#### REMARKS

Applicants have carefully reviewed the Office Action mailed November 2, 2000.

FIG # 3

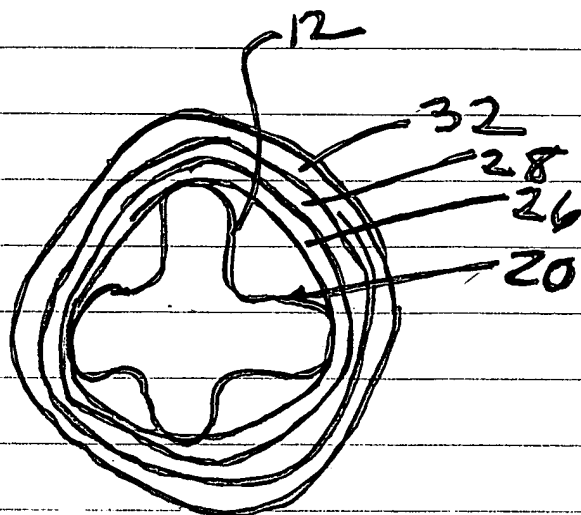
Figure 3 has been redrawn informally to show the Examiner the placement of the various layers referred to in this specification. There is apparently some confusion on the part of the Examiner which applicants would like to rectify. Figure 2 indeed shows the grid 26 between the tube 20 and the filter material 28. The tube 20 is made from a segment 12 which has perforations 14 as shown in figure 4. As stated in the specifications page 4, line 18, the purpose of the grid is to provide support off the tube for the open cell filter media 28. In order to do this the grid is positioned between the tube and the filter media. Since the filter media would normally span the openings 14, the grid 26 provides additional structural strength particularly in the areas of the openings 14. It is now believed that the correction of the drawings particularly the submission of a revised figure 3, which includes no new matter and tracks the language of the specification, now clears up the component assembly for the Examiner. Because of the above clarifications, it is respectfully submitted that the distinctiveness rejections in paragraph 8 of the Office Action have now been overcome. Again, the grid is not outside the filter media in figure 2. The grid 26 is between the filter media 28 and the tube 20 and in that position it acts as a reinforcement against collapse of the filter 28 in the area of the openings 14.

In view of the above amendments to the claims and the redone figure 3 as well as the other amendments to the specification, it is now respectfully submitted that the entire case is in condition for allowance. Applicants will formally apply to the official draftsman to make the requisite changes. Figure 3 is being submitted informally at this time for the Examiner's consideration. The formal drawings will be tendered at such time when the entire case is in condition for allowance. Allowance of the case is requested.

Correction  
Approved  
1/3/01 JH
